REVISED RESPONSE TO REQUEST FOR ADDITIONAL INFORMATION

APR1400 Design Certification

Docket No. 52-046

RAI No.: 301-8280

Figure 1. Probability Density Function (PDF) for Fq Modeling Errors

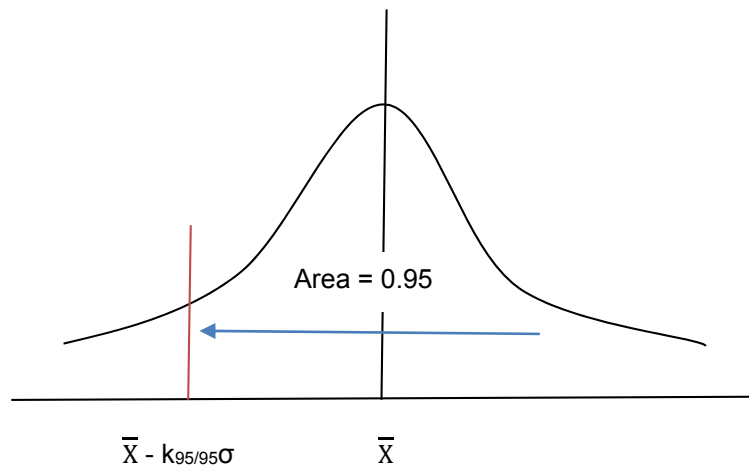
Section 2.1.3, "LPD LSSS statistical methods," of the CPC Setpoint Analysis Methodology Technical Report, states for Equations 2.3 and 2.5 state a normal distribution confidence coefficient of 1.645 for 95% confidence. It is not clear to the staff why these coefficients are consistent with the 95/95 tolerance limit discussion in Regulatory Guide 1.105, Rev. 3, which the staff interprets the limit to correspond to an error distribution approximately equal to two sigma value, 1.96, and not 1.645 as stated in the Technical Report APR1400-F-C-NR-14001. Provide the basis for using this factor with respect to Regulatory Guide 1.105, Revision 3.

The overall uncertainty factor analyses for the core protection calculator (CPC) local power density (LPD) are performed by comparing the 3-D peaking factor (Fq) that is calculated by the reactor core simulator and the peaking factor that is calculated by the off-line CPC, as described in technical report (TeR) APR1400-F-C-NR-14001, Rev. 1, "CPC Setpoint Analysis Methodology for APR1400"

The Fq modeling error (X_F^i) between the CPC synthesized Fq and the actual Fq is defined as follows:

Where $("SYN" Fq)^i$ and $("ACTUAL" Fq)^i$ are the CPC Fq and the reactor core simulator Fq for the i-th case. The Fq error is analyzed for each case at each time-in-life. Approximately 1200 cases are analyzed at each time-in-life (BOC, MOC, and EOC).

The value of 1.645
